ALLEGHENY COUNTY SANITARY AUTHORITY

CONTRACT NO. 1735 G, E, H, P

ALCOSAN PARKING GARAGE

ADDENDUM NO. 1

210-P-01
PLUMBING SYMBOLS, ABBREVIATIONS,
AND GENERAL NOTES

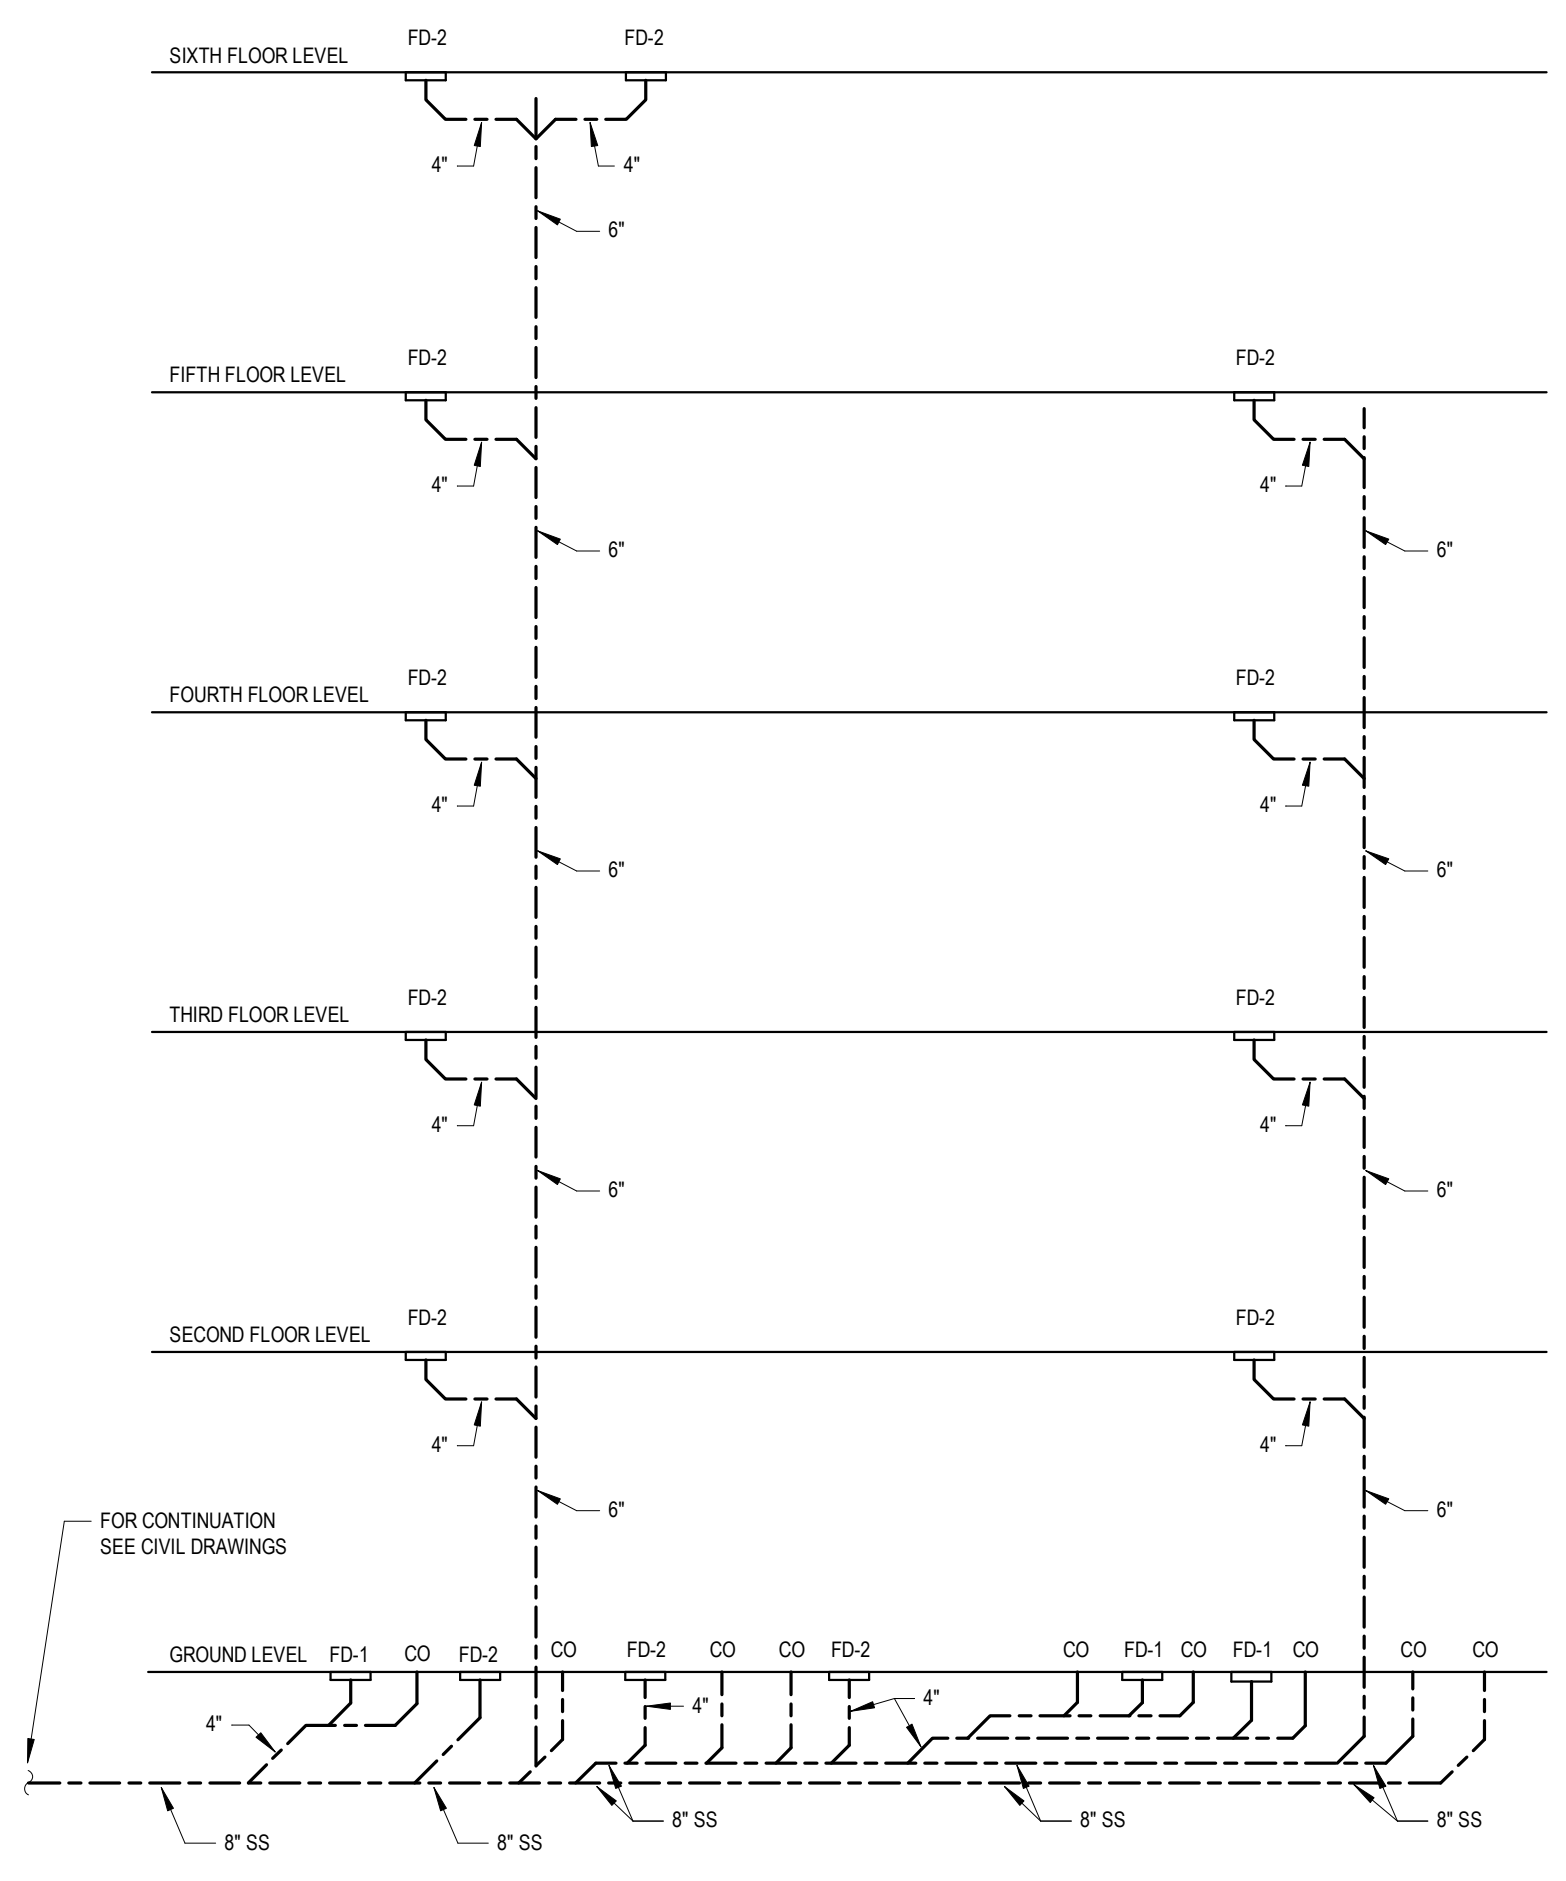
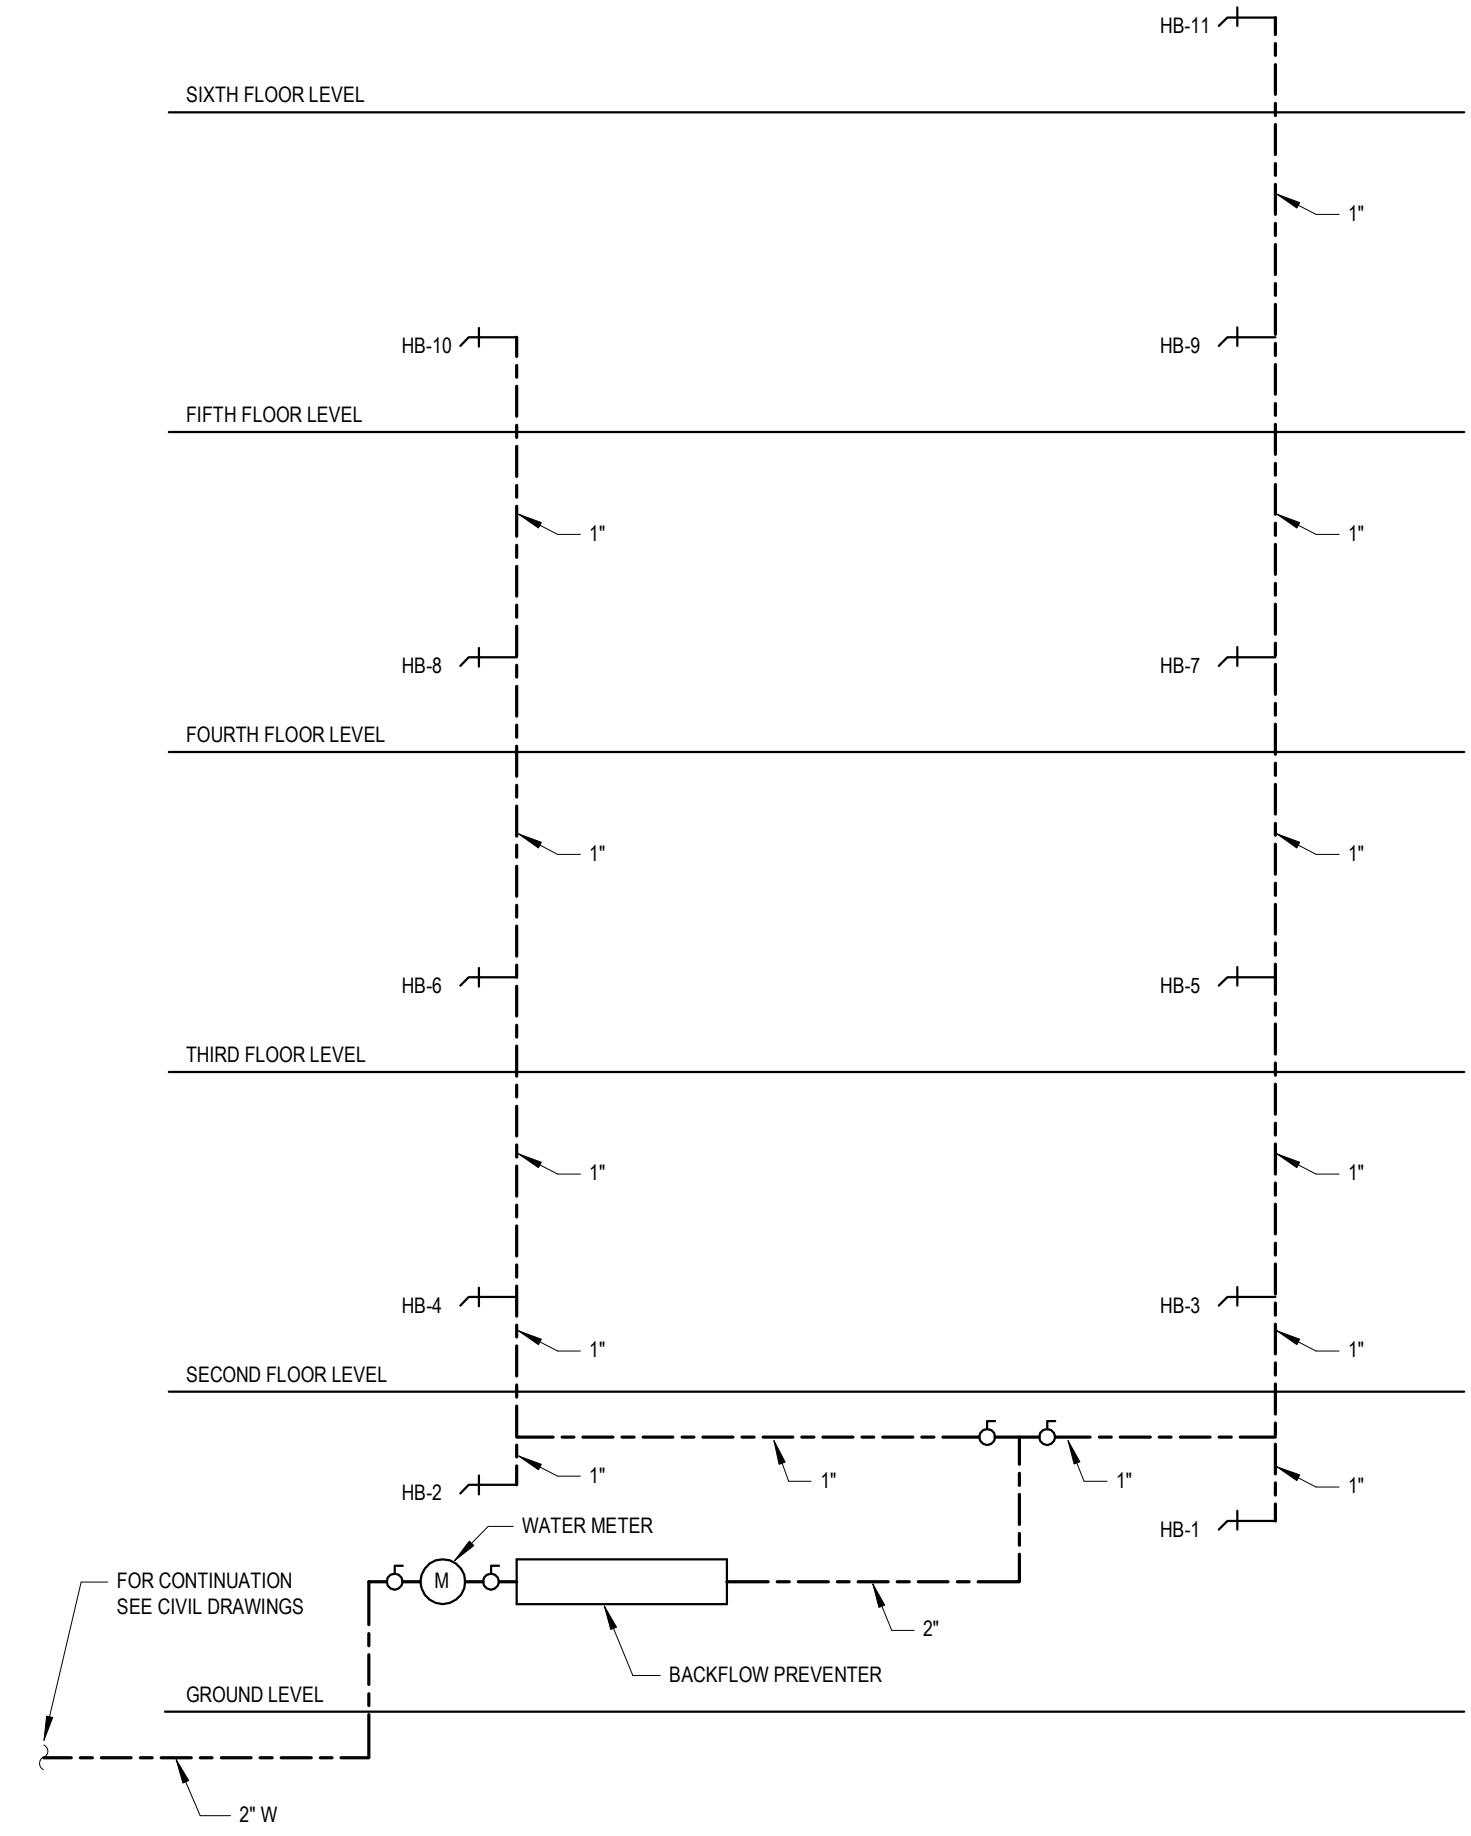
18. Drawing 210-P-01: DELETE this drawing and REPLACE with the attached drawing 210-P-01 to include the floor drain detail removal.
19. Drawing 210-ESL-01: DELETE this drawing and REPLACE with the attached revised drawing 210-ESL-01.

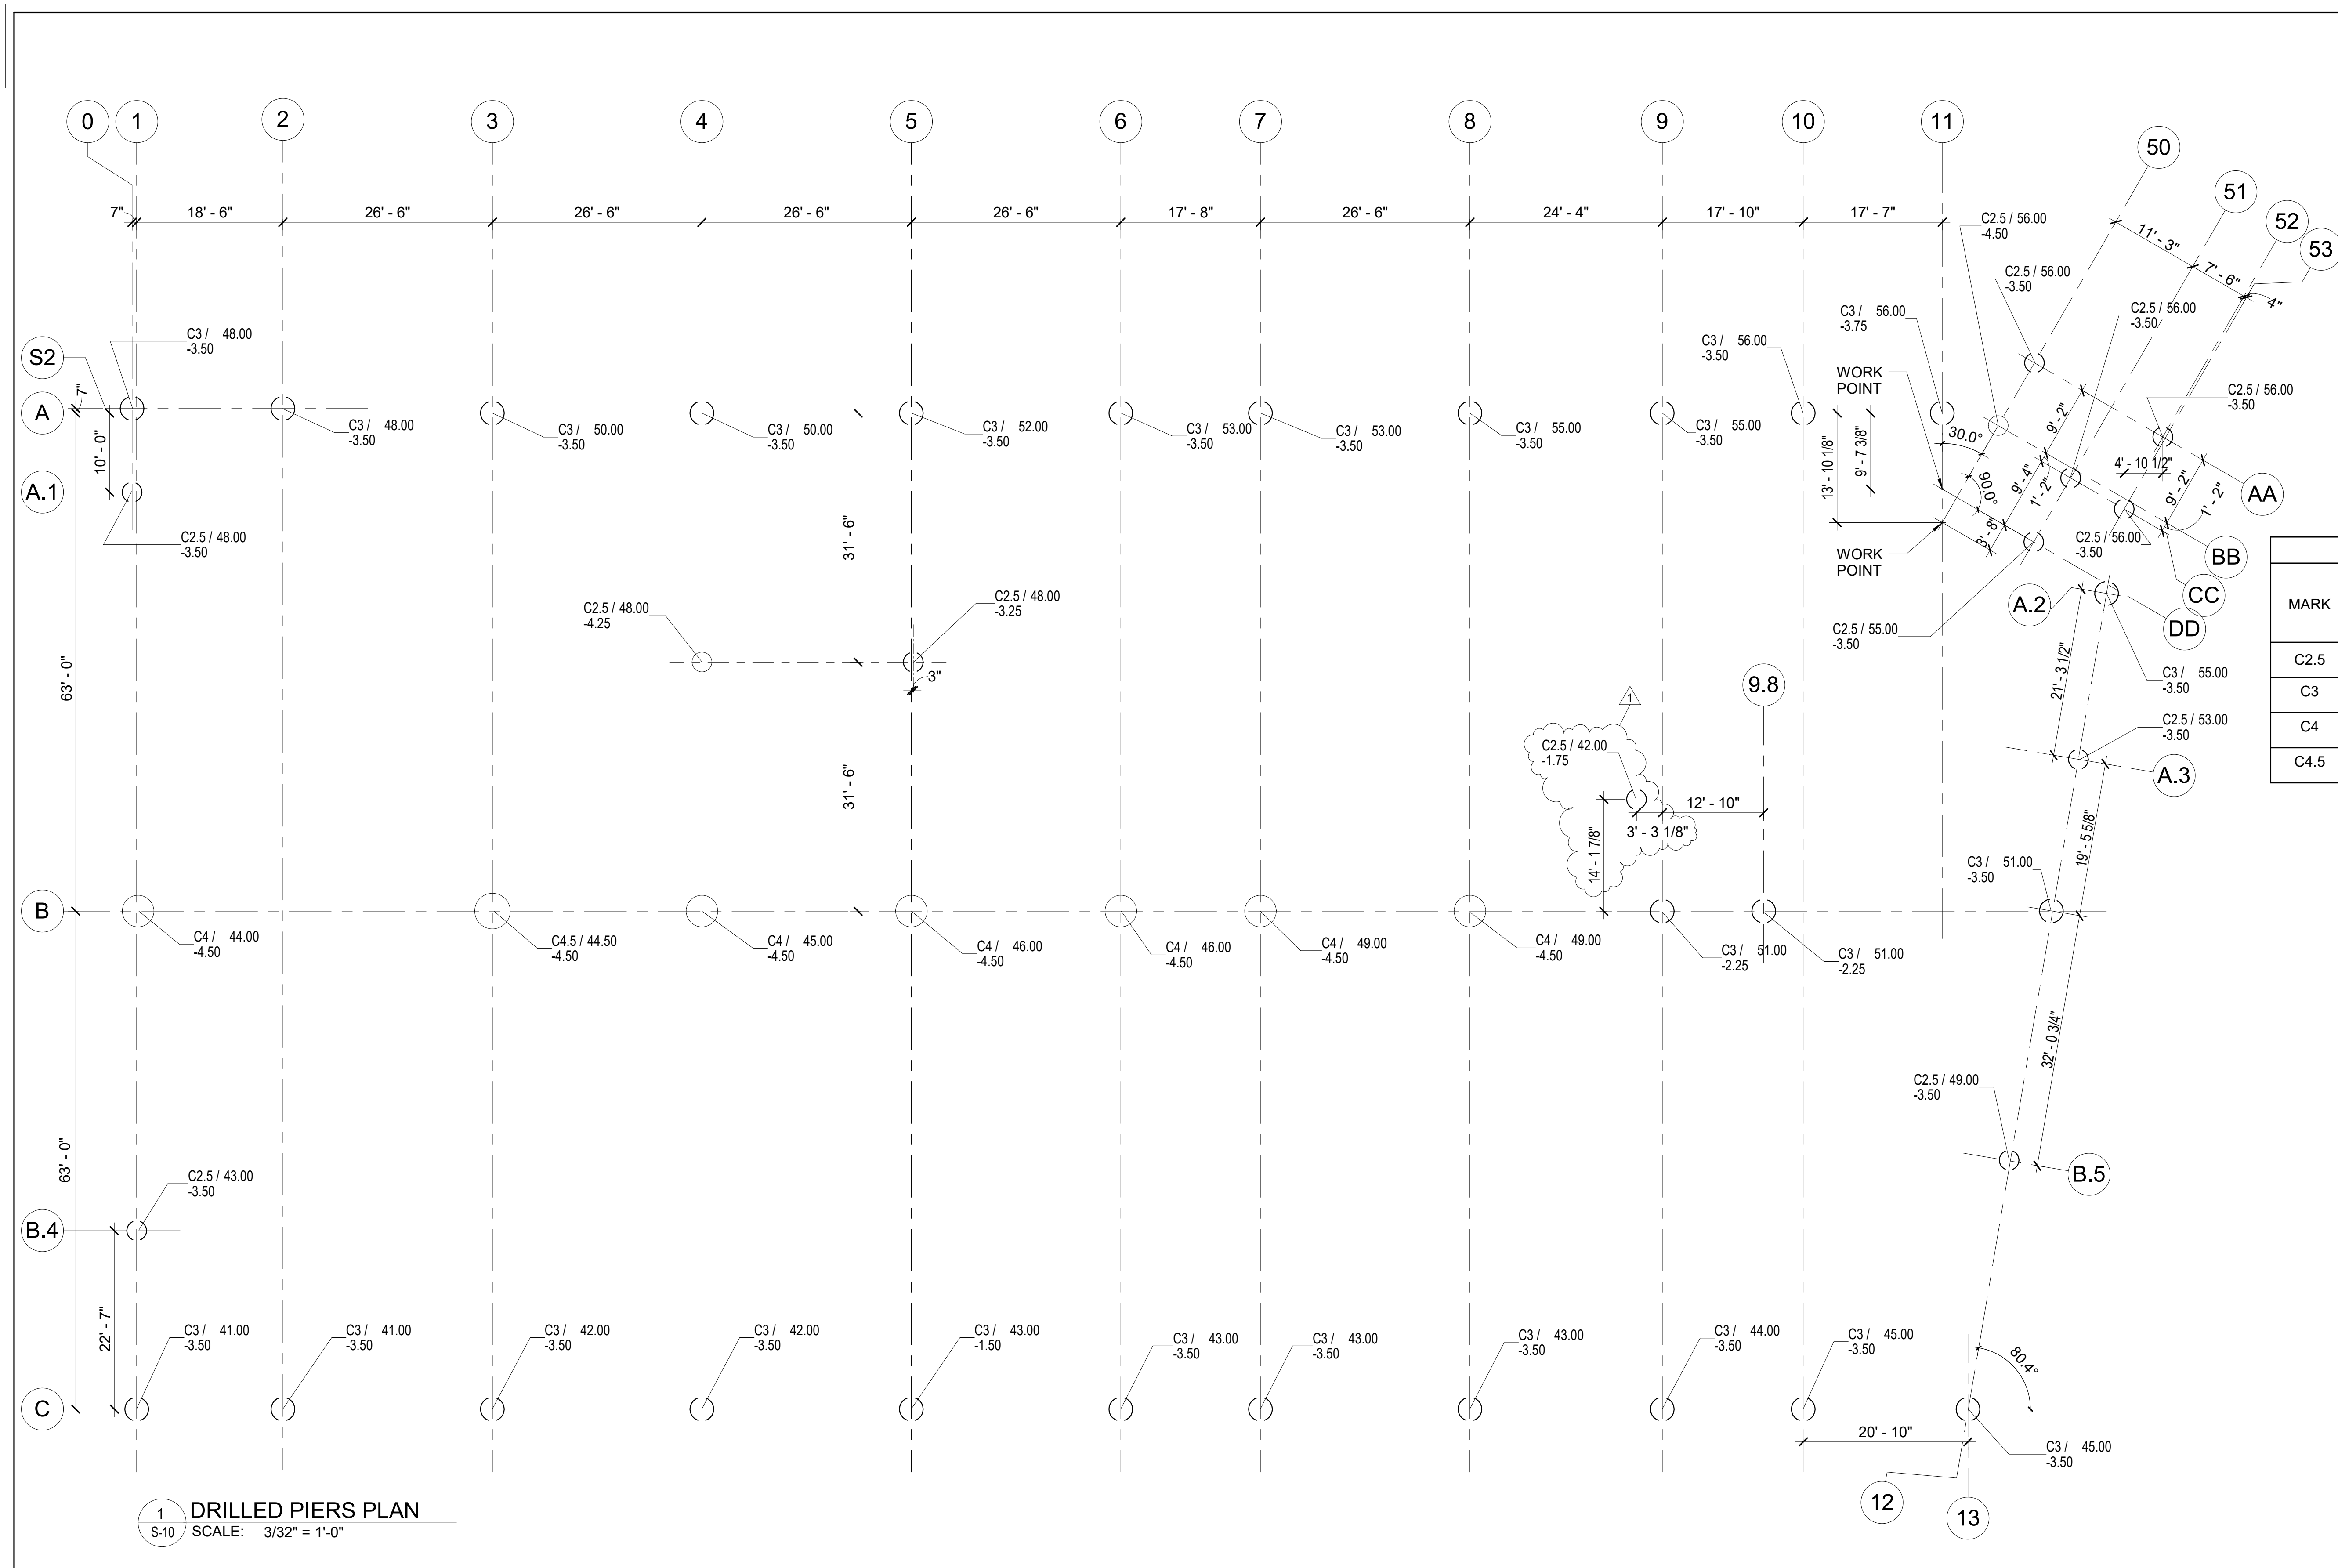
7. Drawing 210-S-10 Caisson Plan (Drilled Piers):
 - a. REPLACE with the attached drawing 210-S-10.
 - b. Caisson 2.5 has been added between gridlines 8 and 9.
